WCHS Track and Field: Change Order #04 Summary

| DATE: | 10/17/2024 | PR #: | PR 006 |
| TO: | Clay Ratliff – Trace Creek Construction | RE: | Woodford County Board of Education Versailles, Kentucky BG 19-353 RTA 1916 Phase 2 |

SA2.1

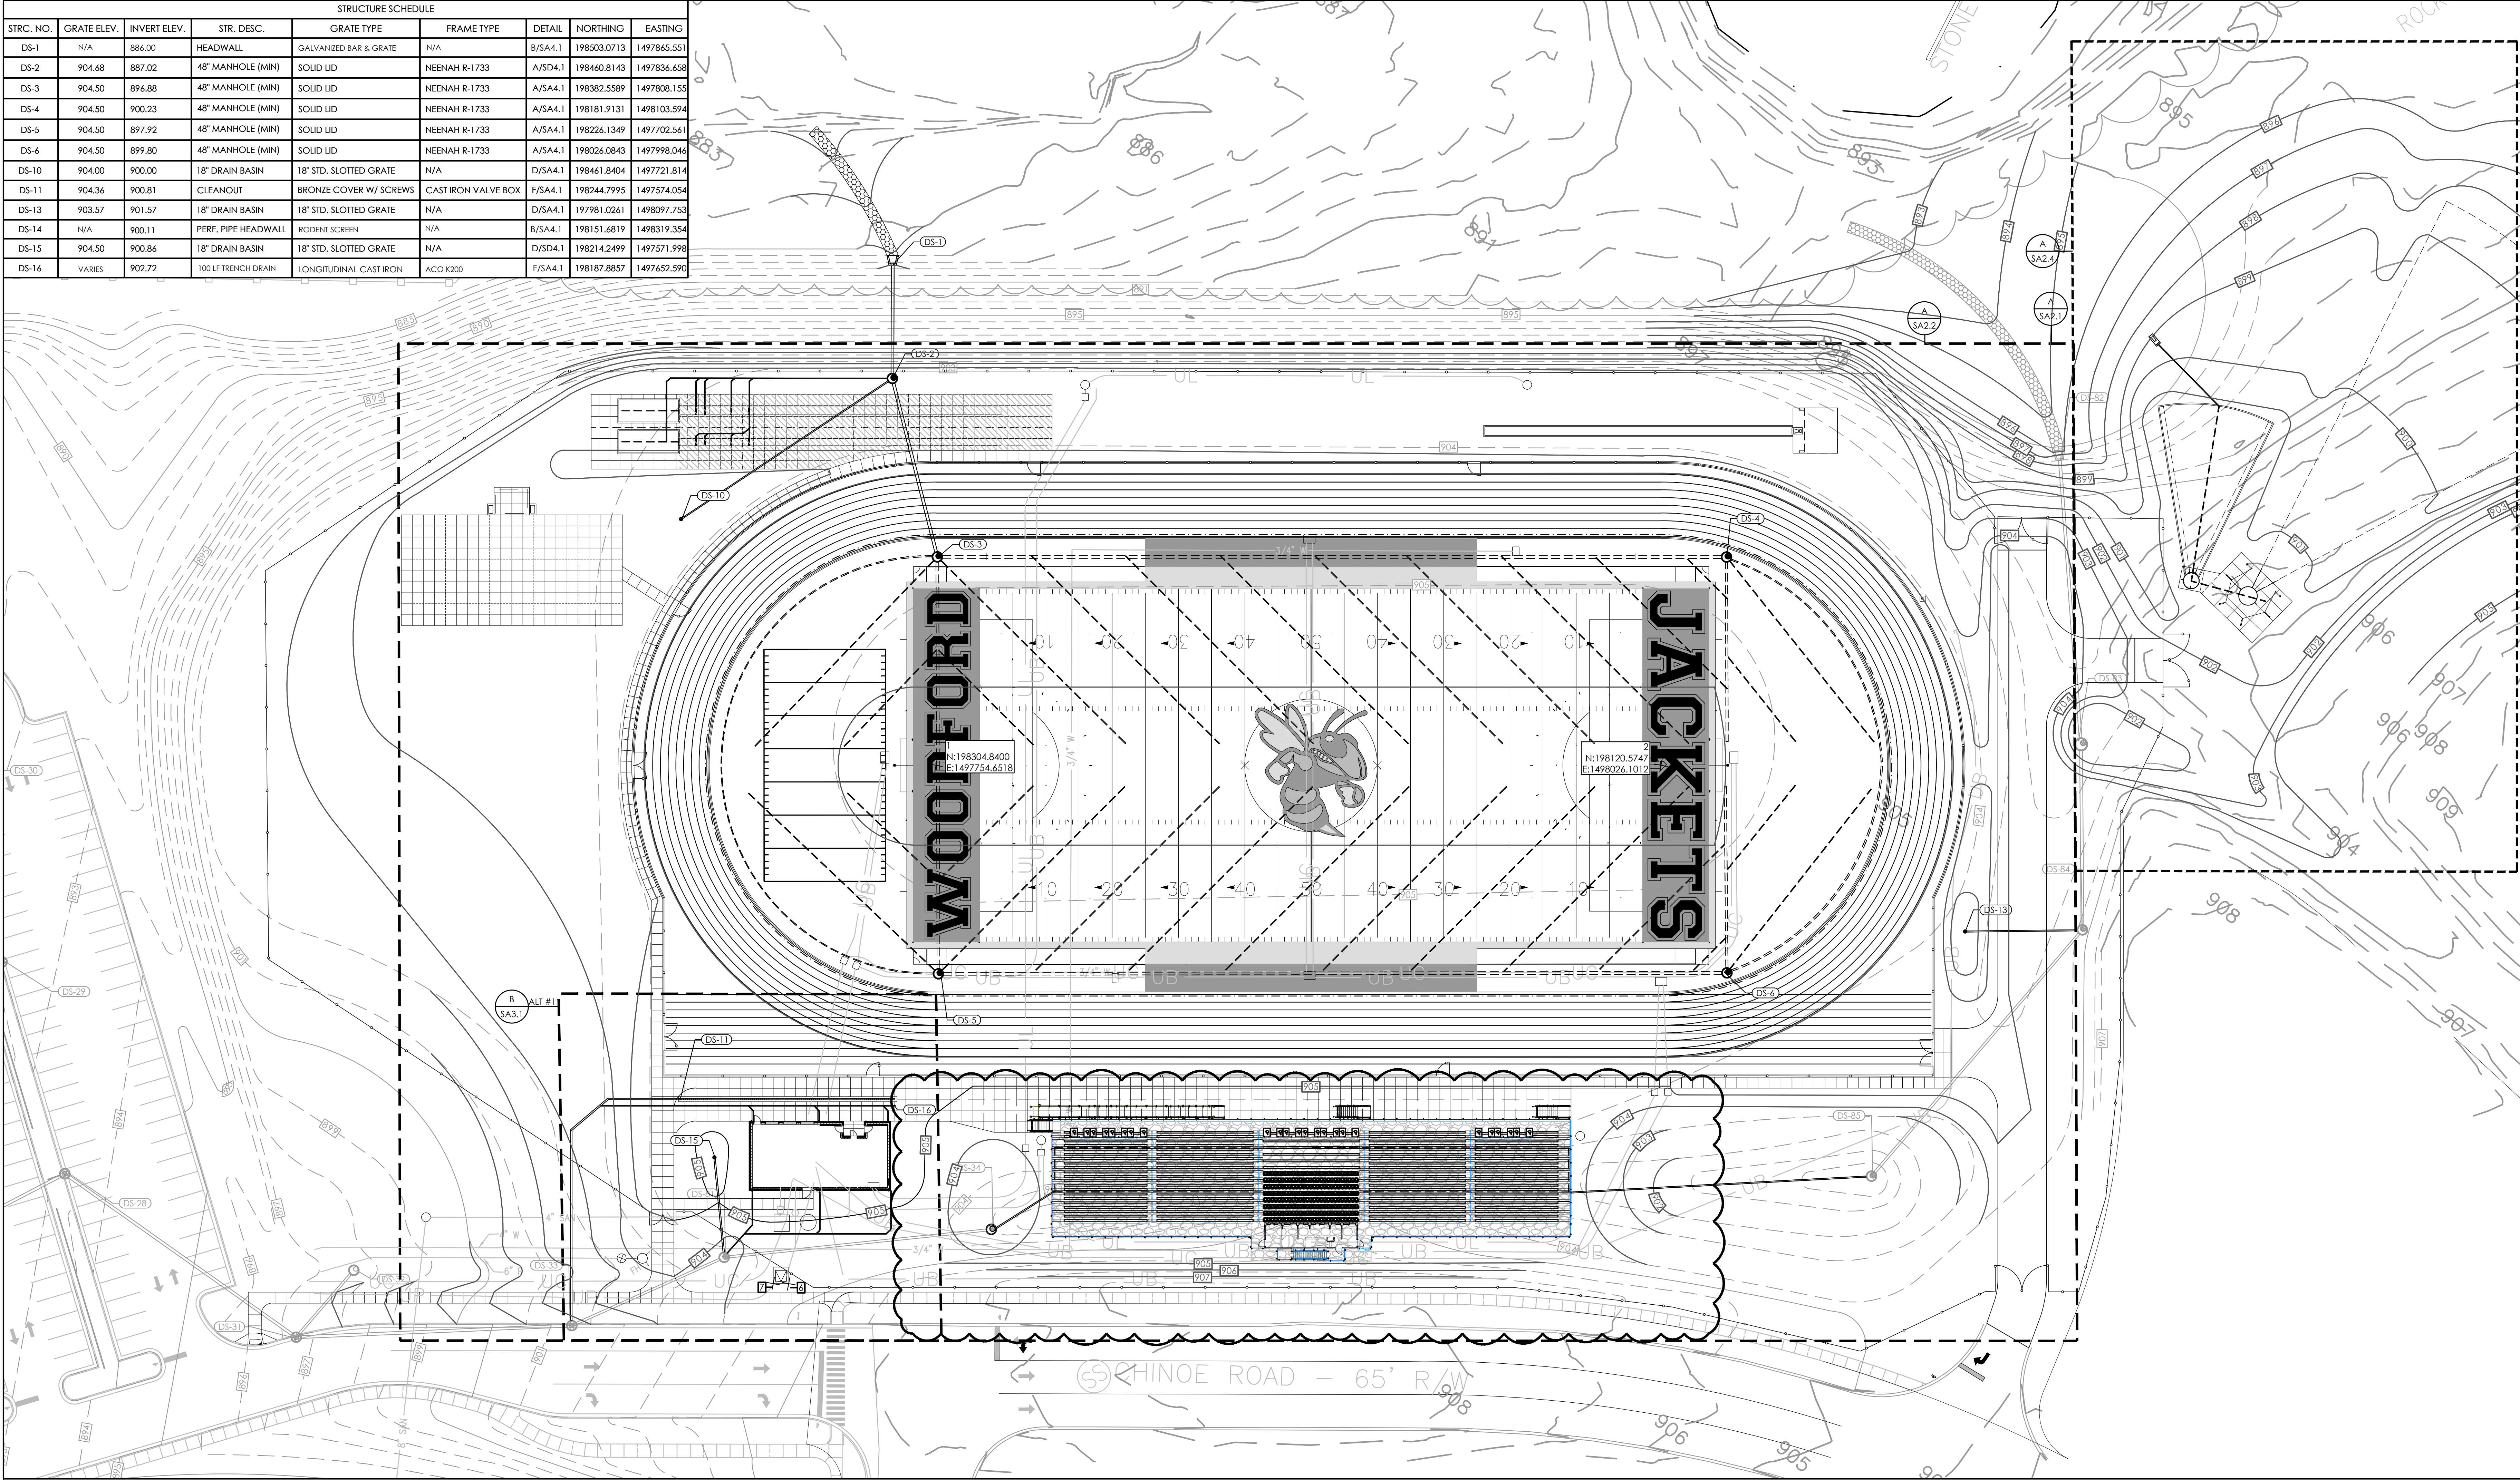
- d) Sod area around bleachers as shown.
 - e) Relocate light poles to be 122' O.C. from the 50-yard line.
2. Refer to SA2.1 – SITE GRADING AND DRAINAGE PLAN:

- a) Modify grading and drainage layout as shown.
3. Refer to SA2.2 – SITE GRADING PLAN:
 - a) Slope new pavement at a 1% from north to south.
 - b) Slope area under bleachers at 2% to low point.

SA2 2

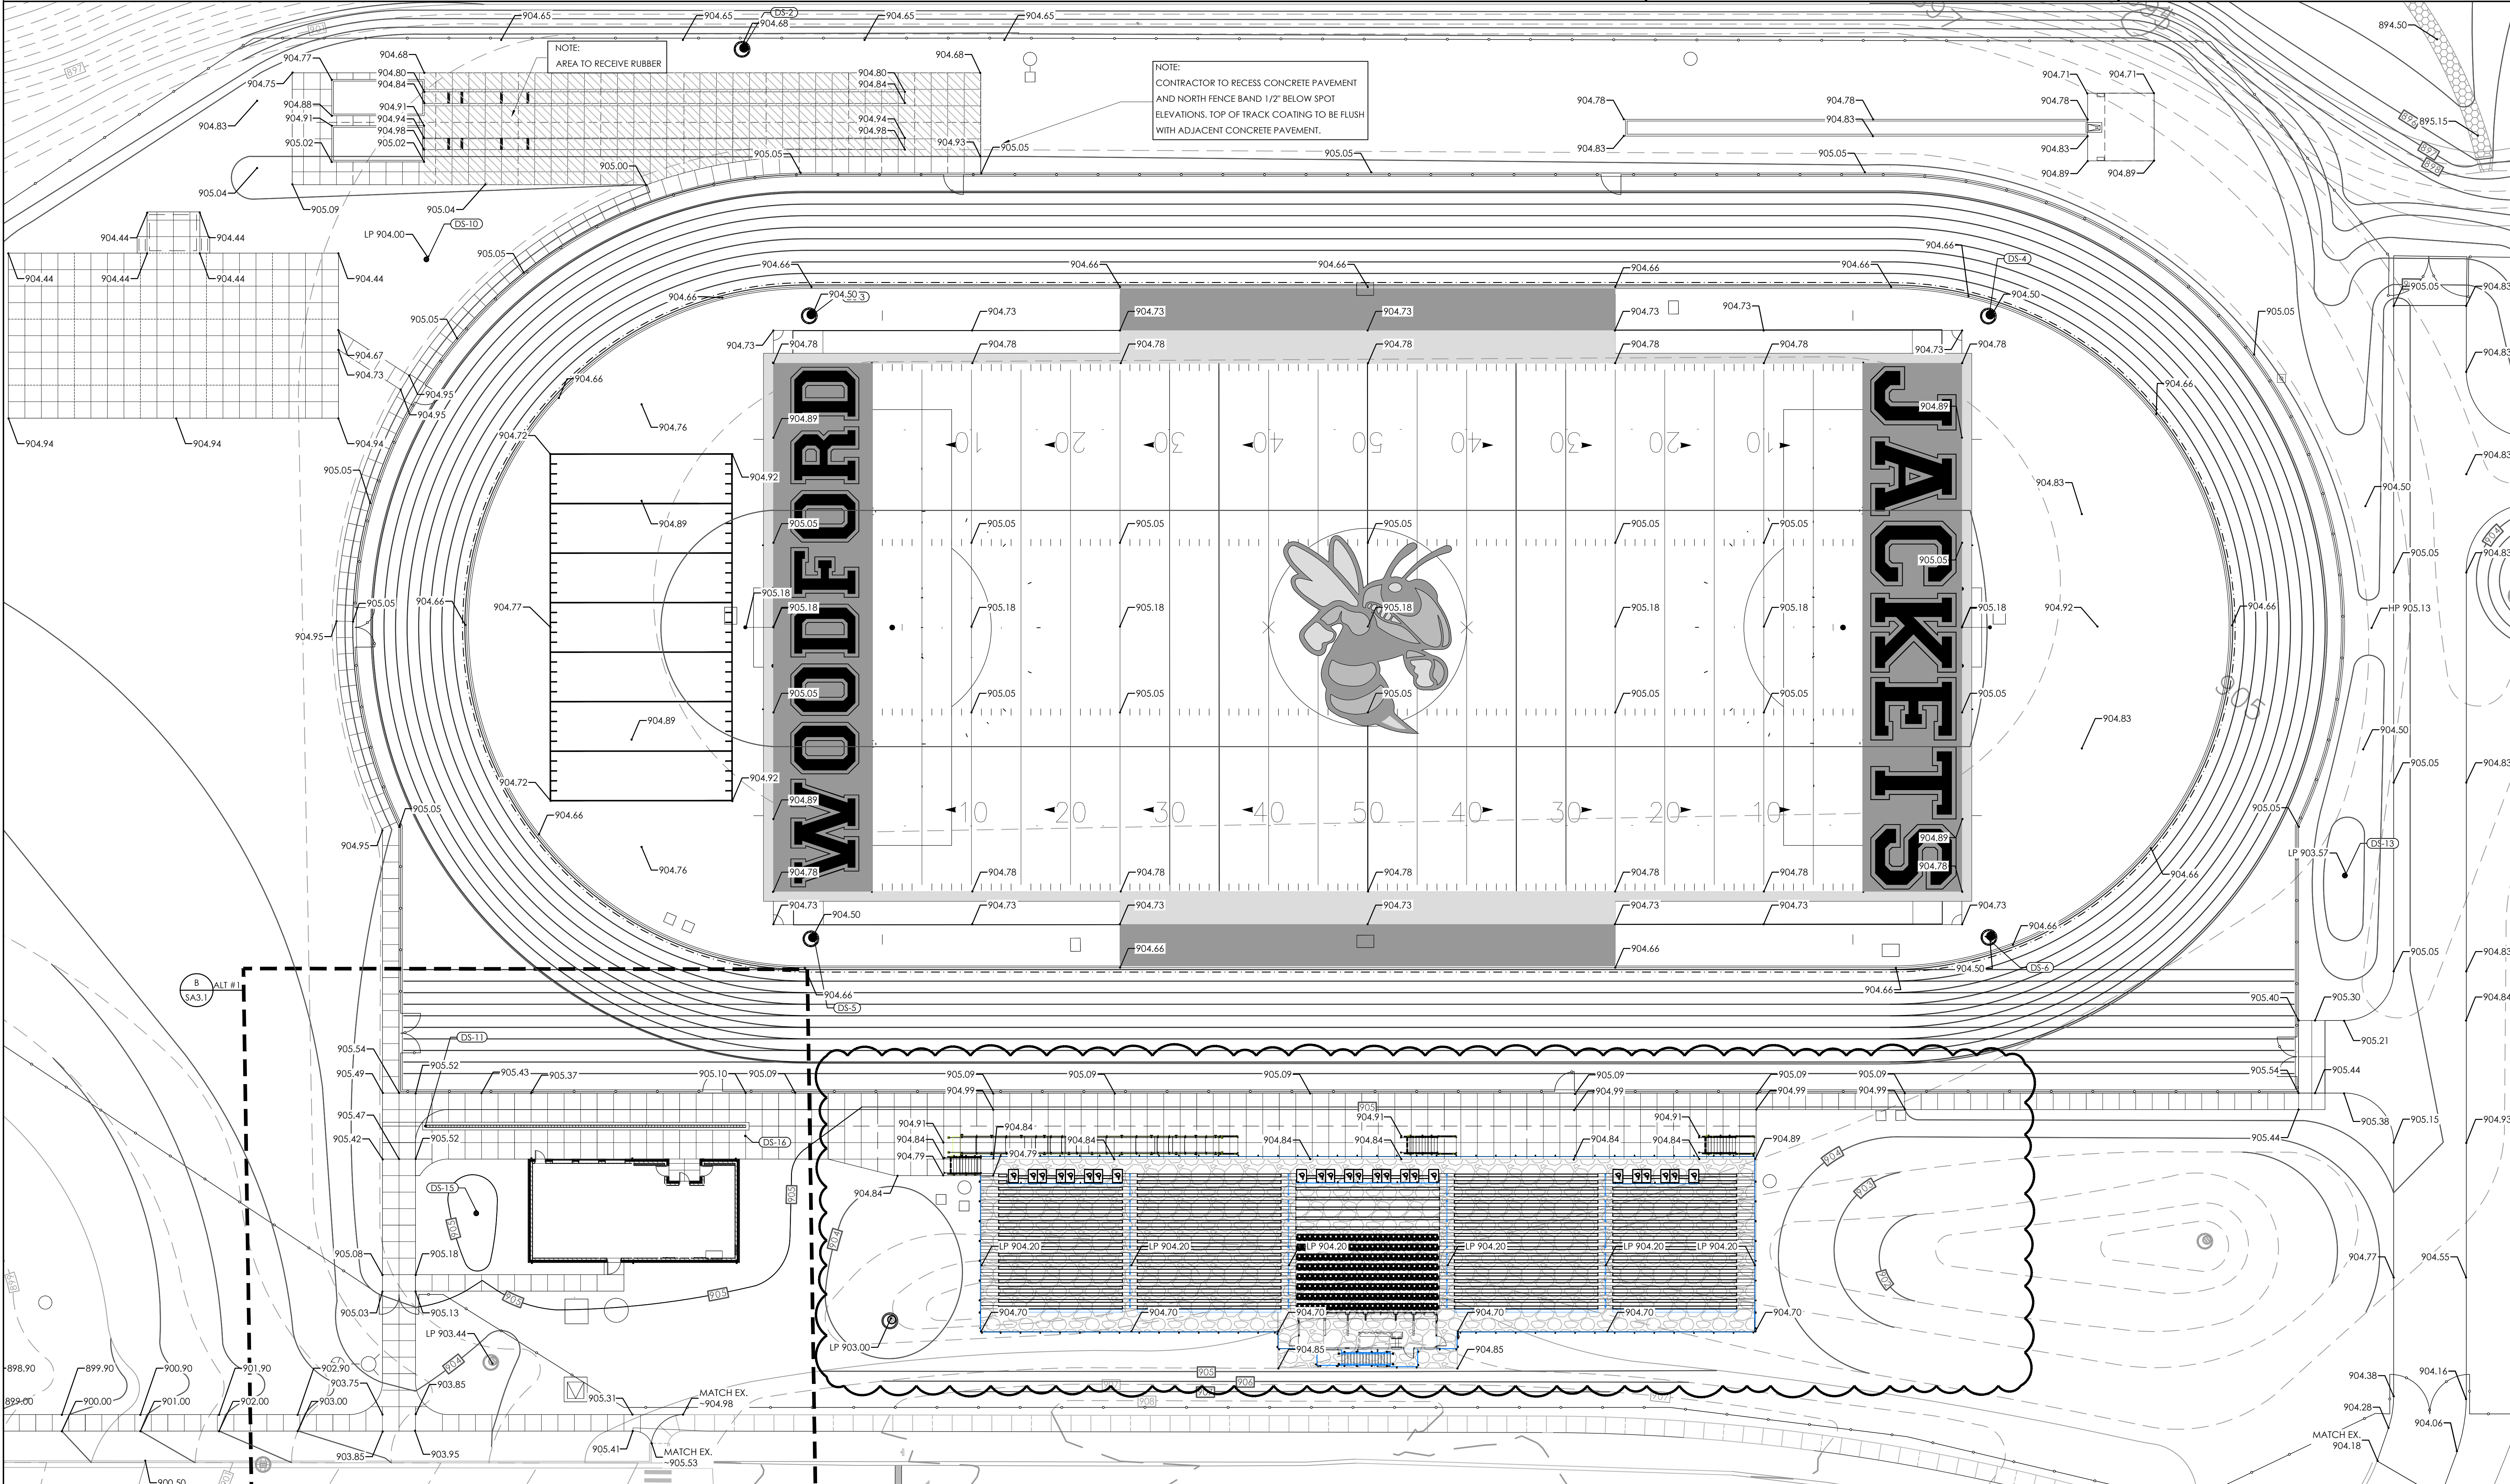
- c) Modify swales to not be under bleachers.
 - d) Raise rim/ground elevation over DS-34.
4. Refer to SA2.3 – SITE DRAINAGE PLAN:
 - a) Add perforated piping under bleachers as shown. Space perf pipes 20' minimum O.C. Space around bleacher foundations.

SA2.3

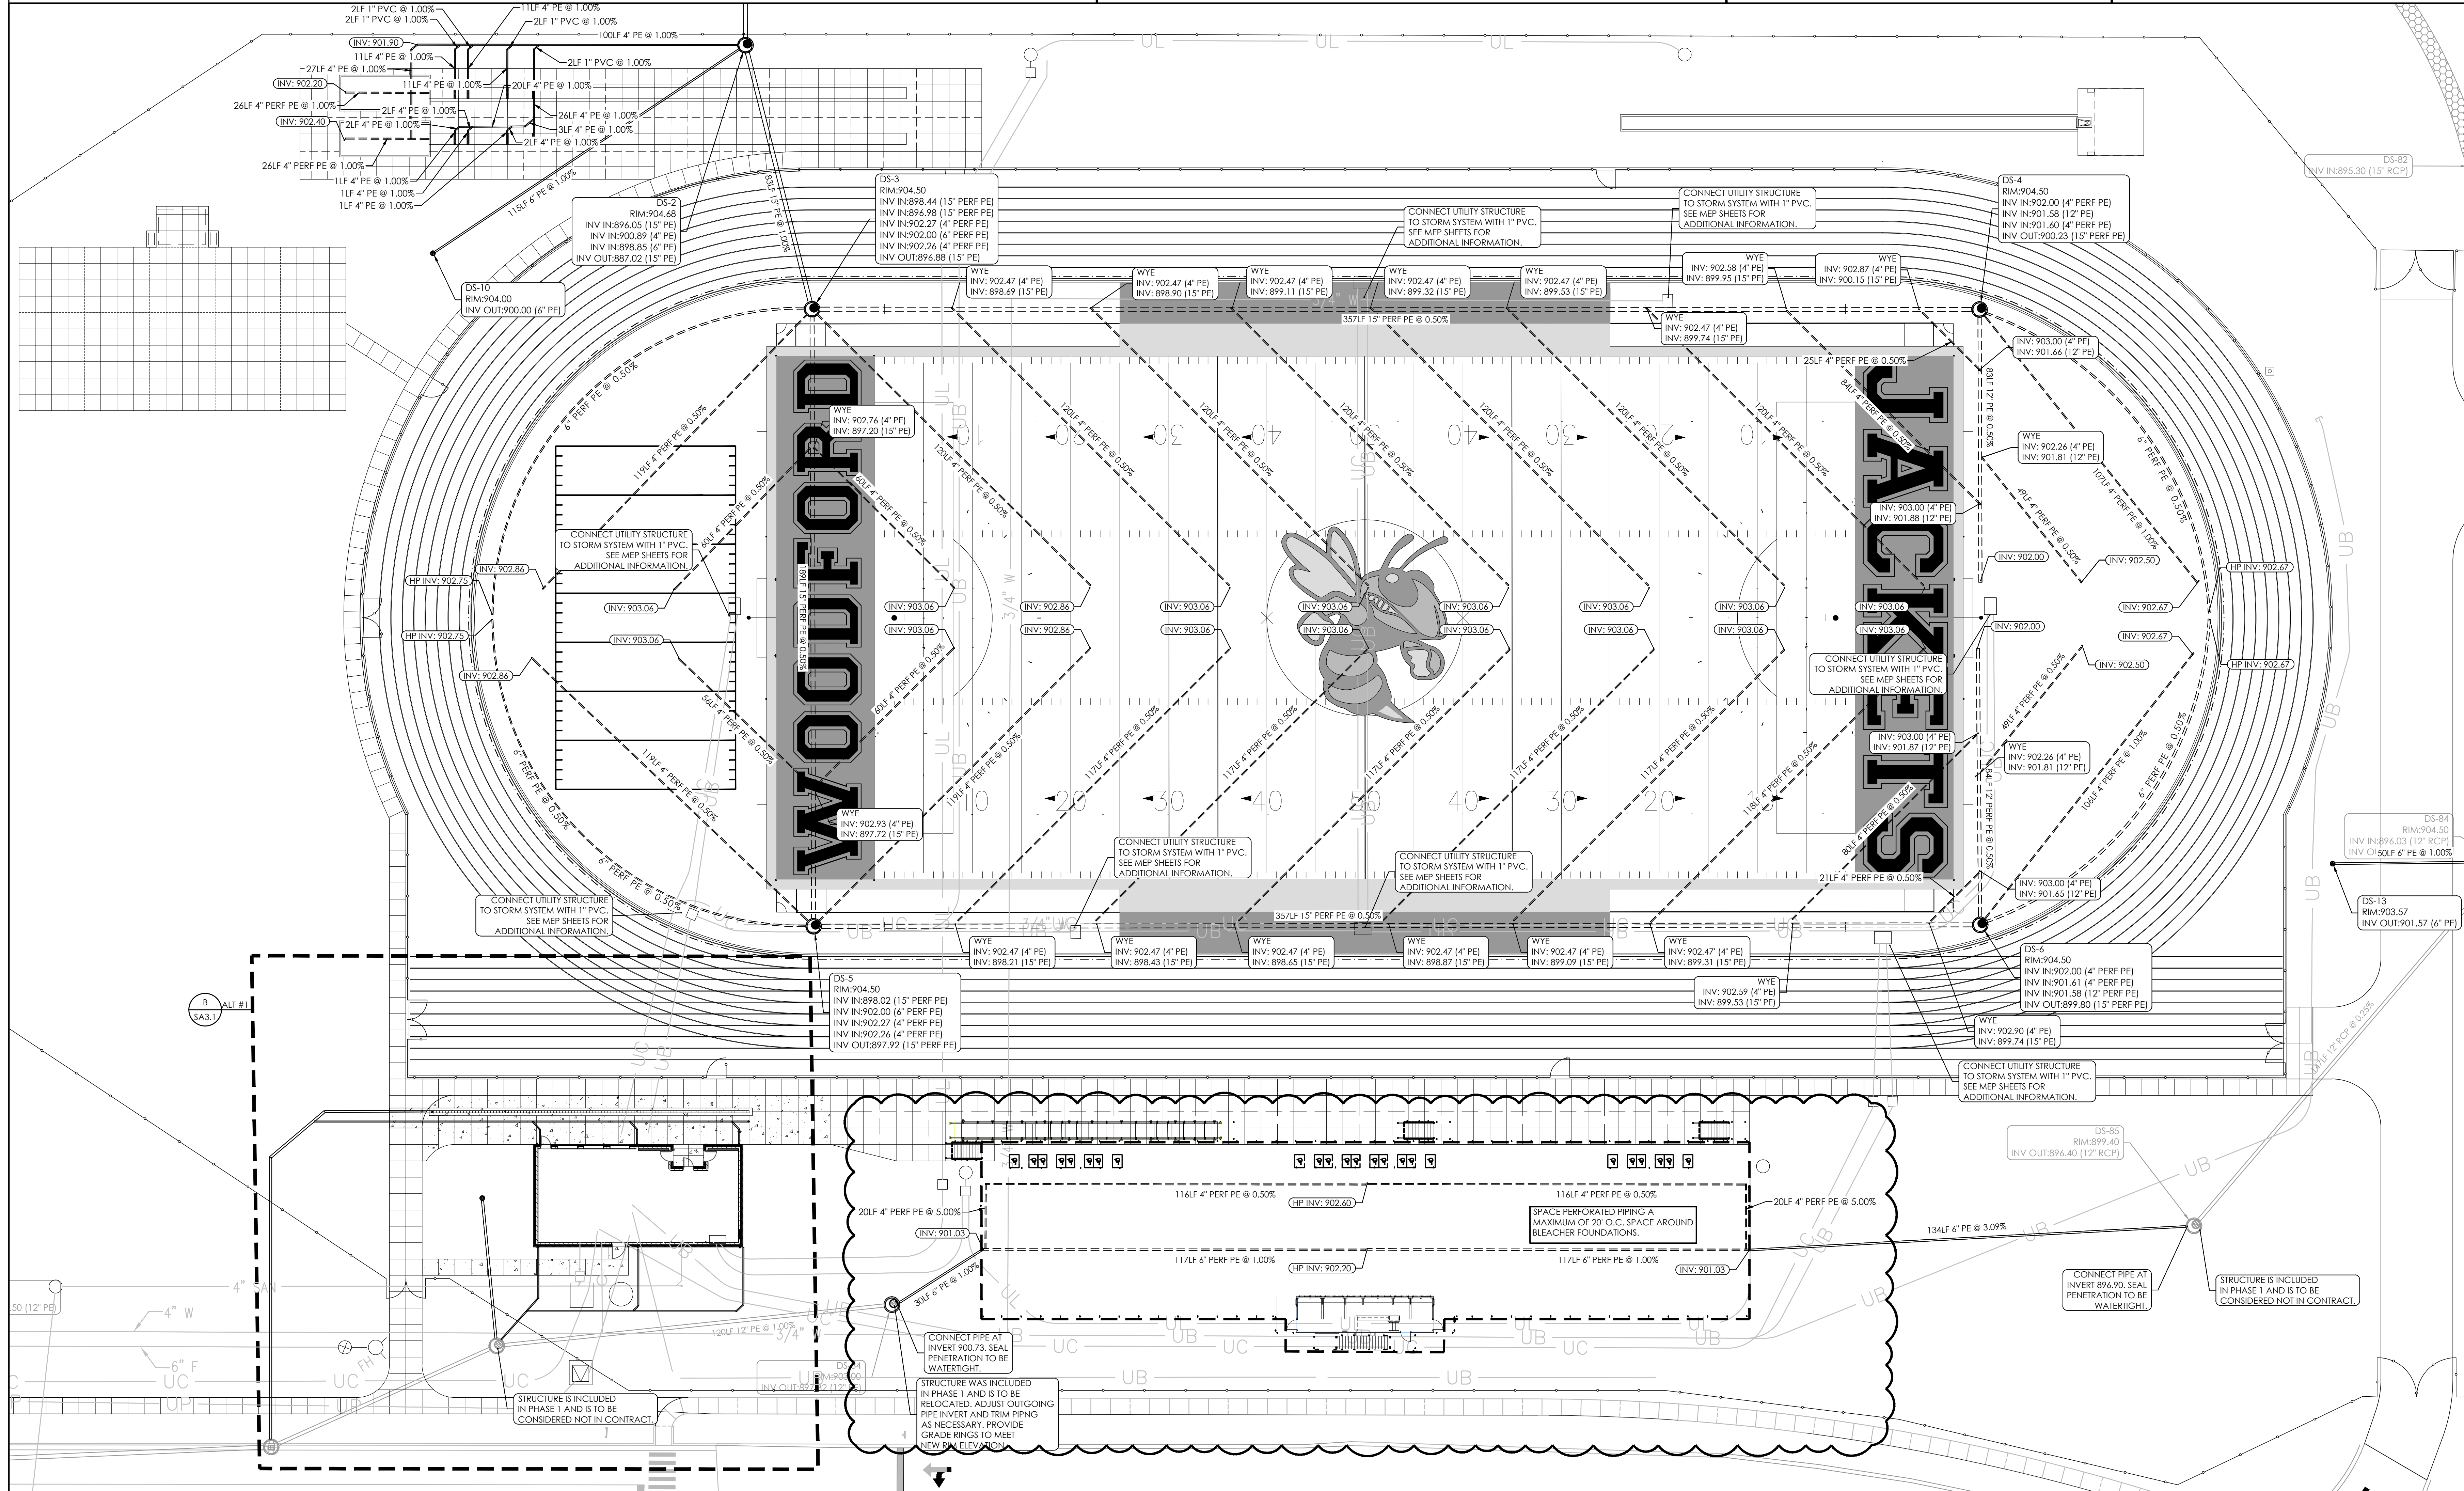
- b) Relocate manhole DS-34 along the outgoing pipe. Adjust piping length and add risers to manhole to meet new grade/rim elevation.
 - c) Tie perforated piping to DS-34 and DS-85. Seal penetrations to be watertight.
